CITY OF SOUTH ST. PAUL MEETING AGENDA

PLANNING COMMISSION

Wednesday, August 6, 2025
7:00 PM

A motion recommending approval or denial of conditional use permits, a site plan review, a master sign plan, and an amendment to an existing conditional use permit for a planned unit development for a Holiday Station Store at 677 Concord Street South.

CITY PL. NO.
STRT-1

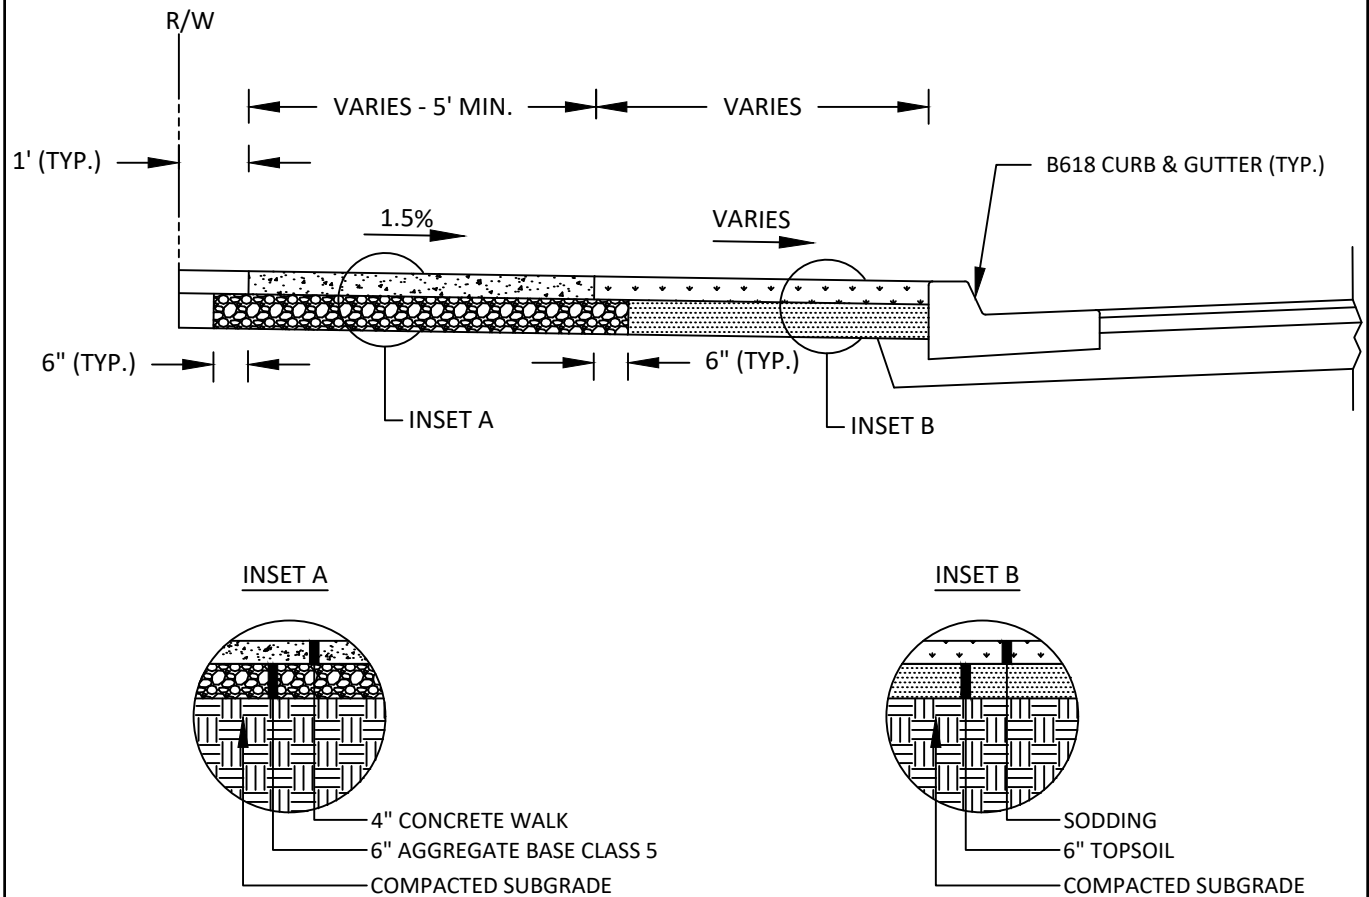
4. Applicant to include current City Detail Plates STRT-1, STRT-3 and STRT-5 in place of those currently shown on sheet C500.
5. A traffic control plan will be required prior to construction for the work on Villaume Avenue.

CITY PL. NO.
W-2

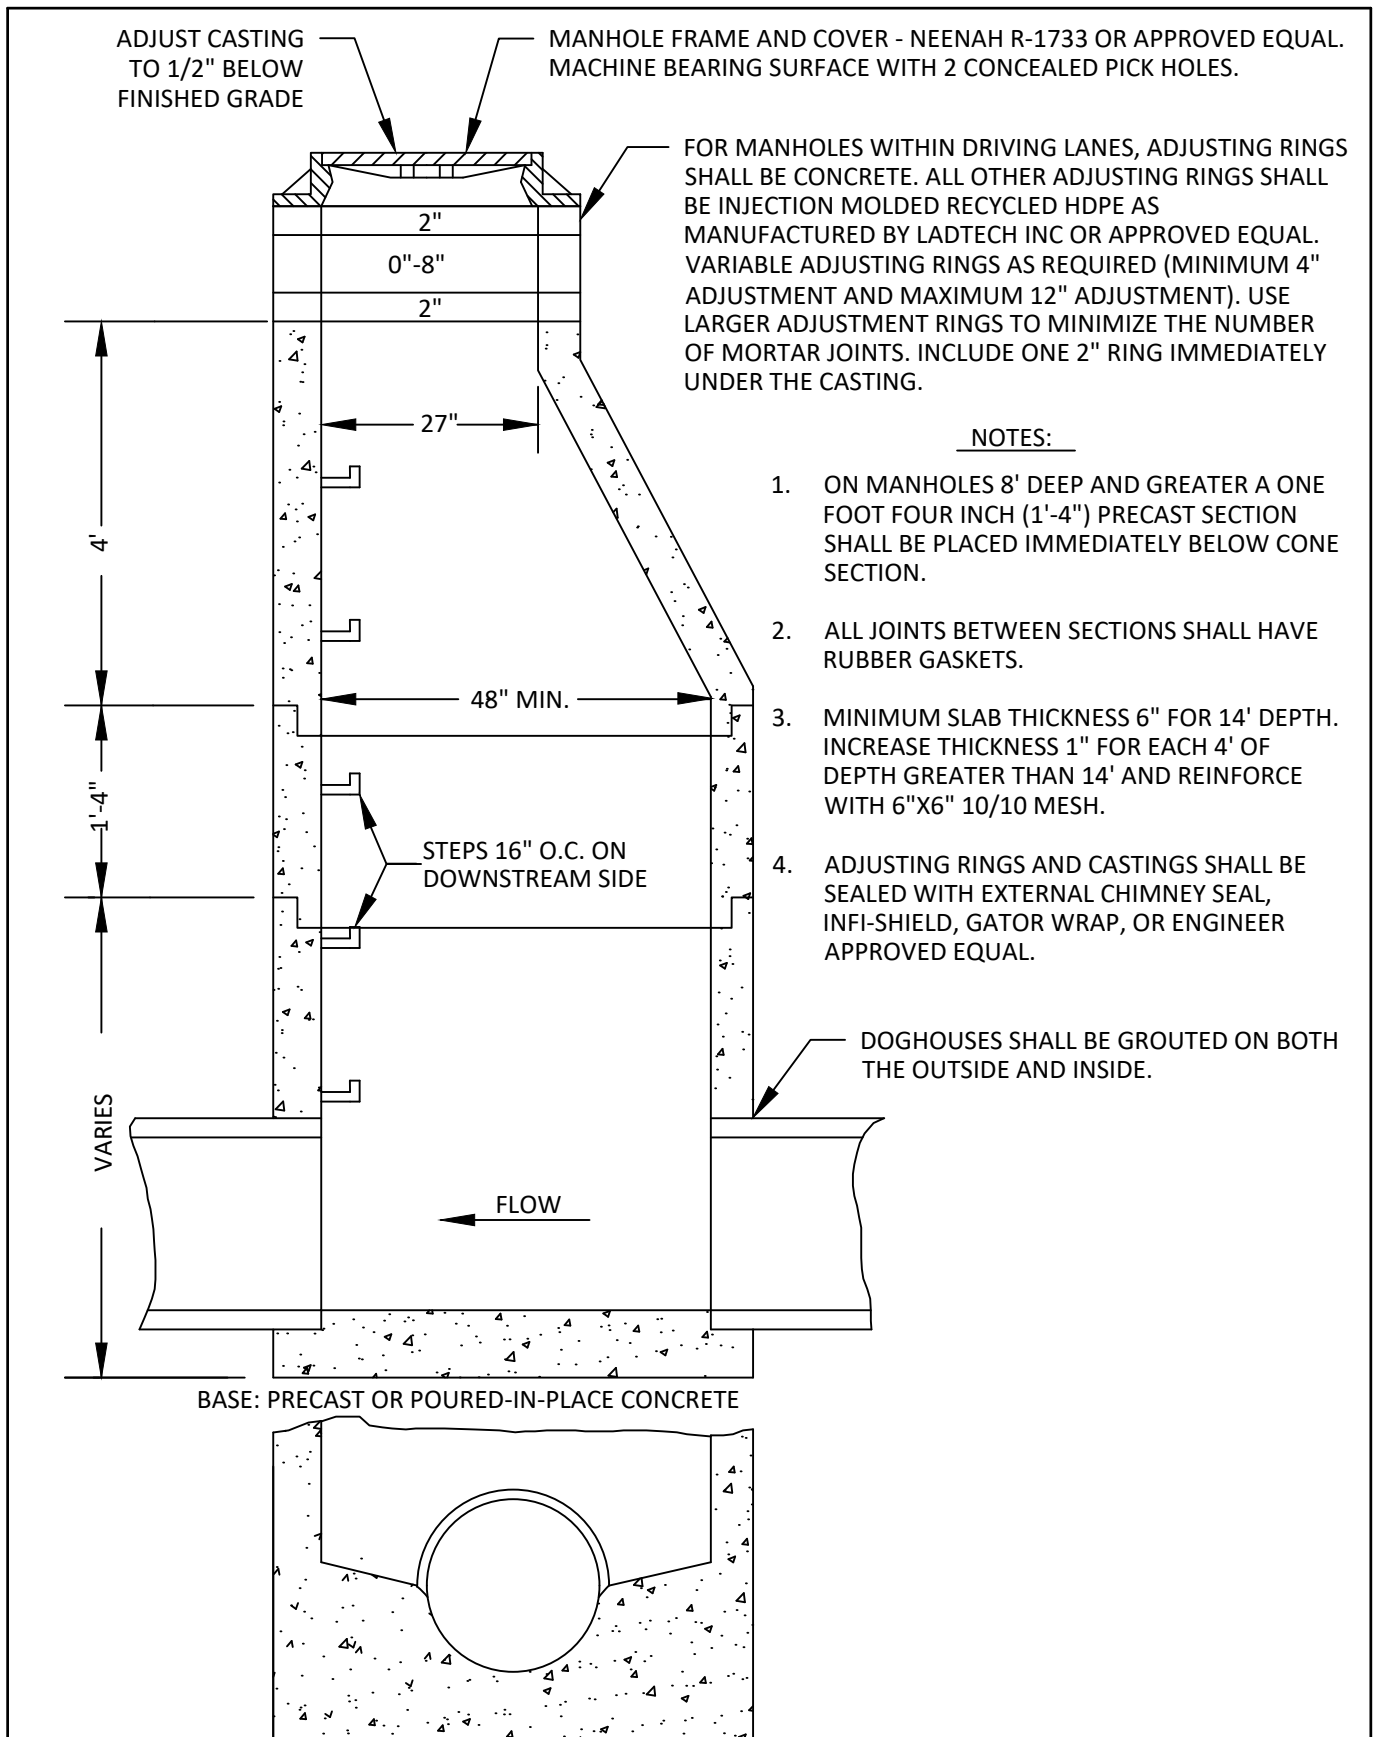
3. The proposed location for the relocated hydrant is acceptable. However, due to the age and condition of the existing hydrant, the applicant shall supply and install a new hydrant per City Detail Plate W-2. The pavement removal on Villaume Ave shall be at least 10' wide to accommodate hydrant work.
